**City of Lake Elmo
Planning Commission Meeting
Minutes of October 10, 2012**

Planning Commission
Date: 10/22/12
Item: 4a
Business Item (Cont.)

City of Lake Elmo Planning Department
Conditional Use Permit Request

To: Kyle Klatt, Planning Director
Cc: Nick Johnson, City Planner
Jack Griffin, P.E., City Engineer
From: Ryan Stempksi, P.E.

9242 HUDSON BOULEVARD
LAKE ELMO, MINNESOTA
**FINAL GRADING, DRAINAGE, EROSION,
& SEDIMENT CONTROL PLAN**

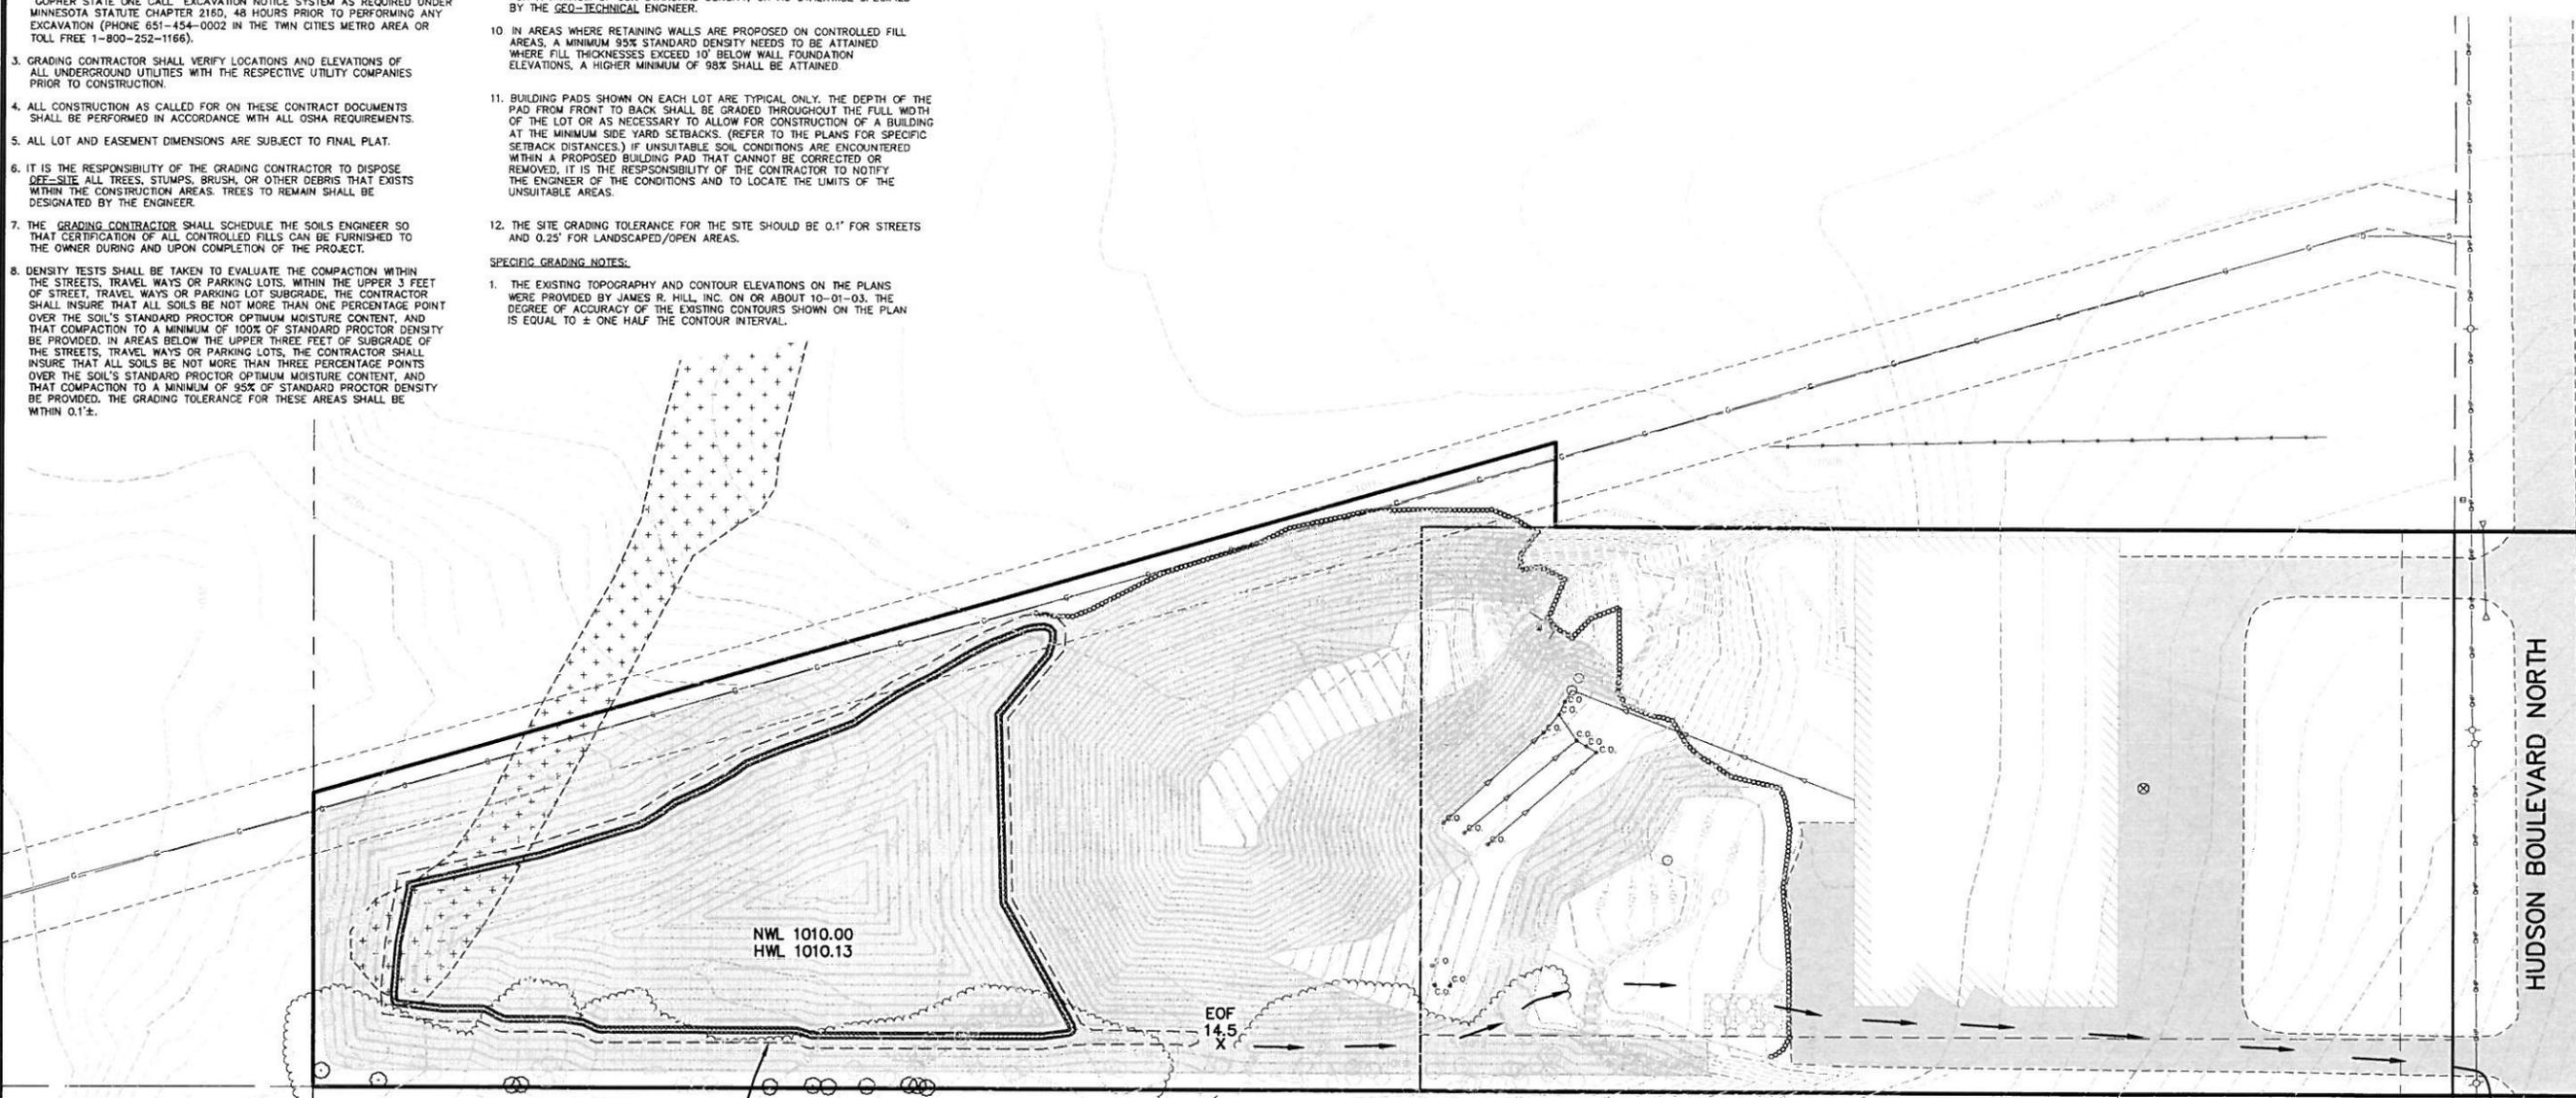
1. The Grading Plan (Sheet 2.3) must be revised to show protective fencing around the drainfield prior to construction. Long term protection from the drainfield area must also be provided in the plan.

4. A stormwater pond detail must be provided to show a side slope of 10H:1V for the first 10 feet, then a maximum of 3H:1V beyond the first 10 feet. The Grading Plan (Sheet 2.3) must be revised accordingly.

1. We have revised the grading plan so there will be no fill placed over the existing drainfield on-site. The location of the drainfield is shown on the plan.
2. We have revised the grading plan to allow for a maintenance access from the existing parking lot.
3. The grading plan modifications made have not changed the drainage areas or pond size so that the current drainage model is still reflective of our proposal.
4. We have revised the pond easement sketch to include the maintenance access road.
5. The easement is reflective of the pond on the grading plan which is established to maximize the ski-hill feature that is the basis for the project. This is a temporary pond and it is anticipated the maintenance of this pond will be provided by the owner.

9242 HUDSON BOULEVARD
 LAKE ELMO, MINNESOTA
TREE INVENTORY PLAN
 FOR
JOE HEINEN
 595 LAKE RIDGE DRIVE, SHOREVIEW, MN 55126

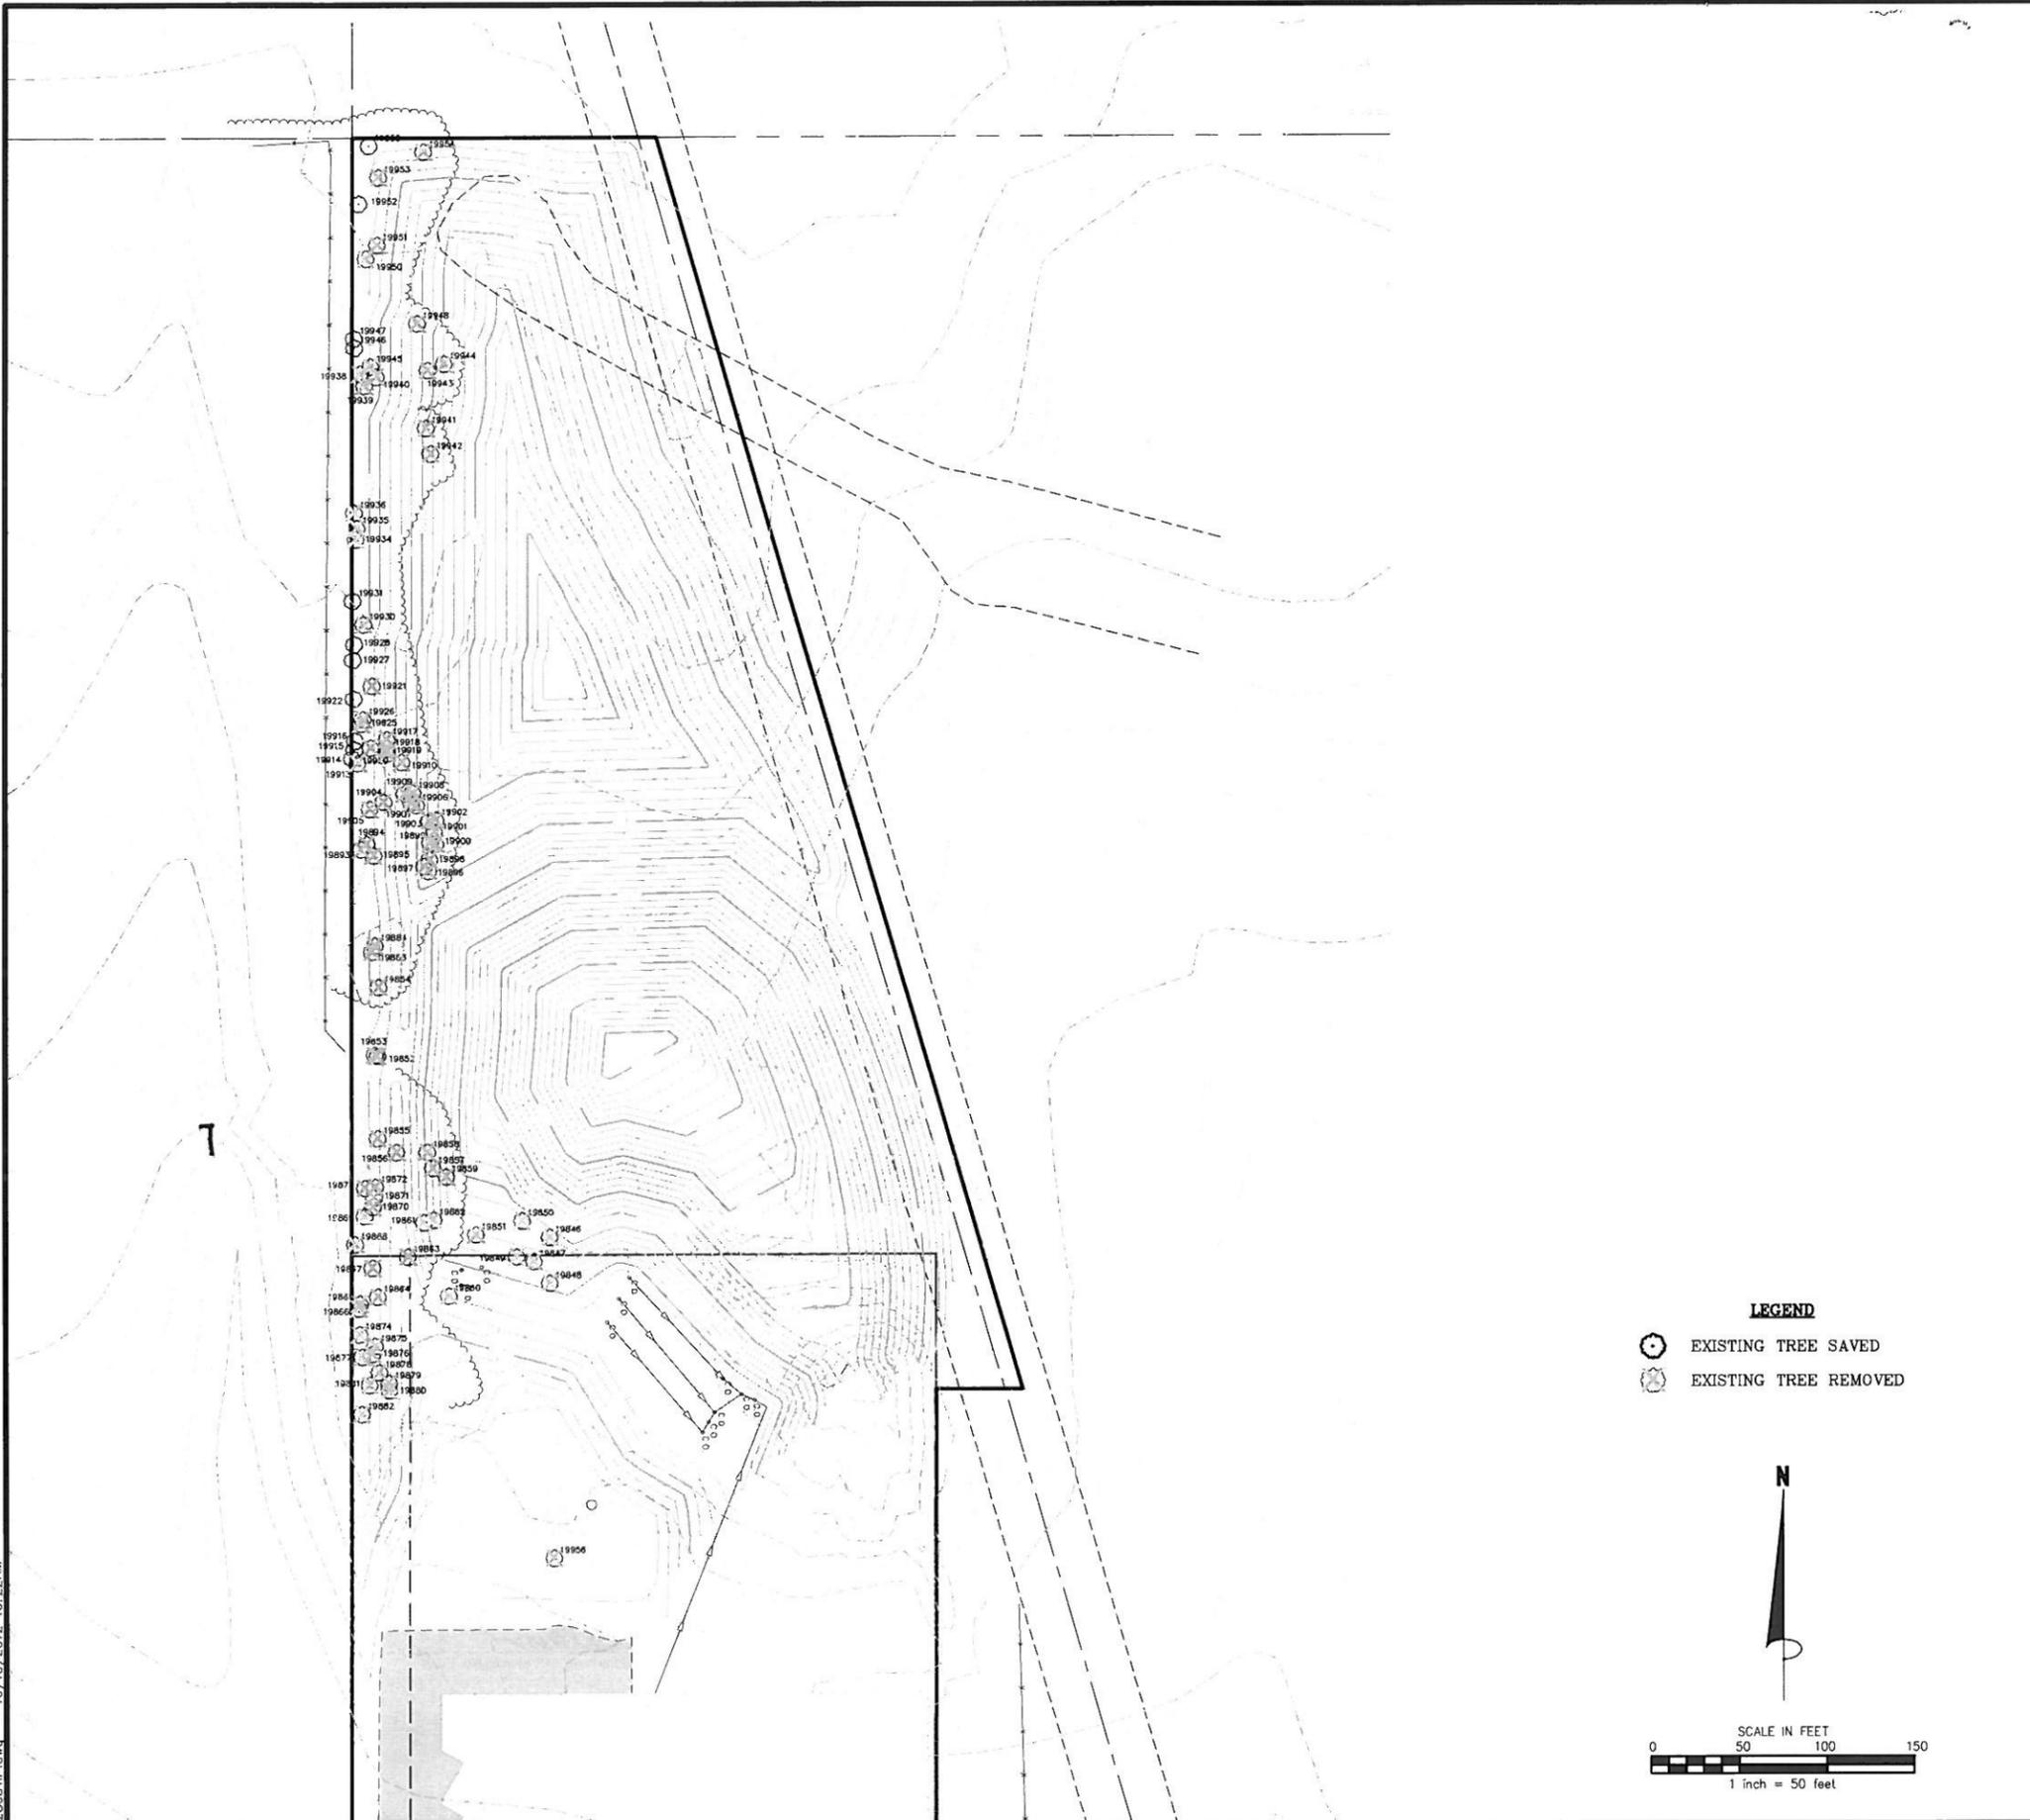
- There are a number of trees that will be removed due to the grading. The applicant has submitted a Tree Inventory Plan that indicates 22.7% of the trees will be saved. Staff is recommending that some of the trees lost be replaced in order to better bring the project into conformance with the City's grading permit standards.

5. The Tree Inventory Plan indicates significant tree removal as part of this project. A majority of the existing trees along the west property are shown for removal. The City should consider the provisions of the City Code in Section 151.017 (J) Grading Permit standards as they reference efforts to minimize tree removal, maintain screening, and restore site aesthetics through landscaping.

- 2) The applicant shall submit a landscape plan for review and approval by the Planning Director prior to the commencement of any grading or filling activity on the site. The landscape plan must include a total number of trees equal to at least 50% of the number that presently exist on the site and as documented on the provided tree protection plan.
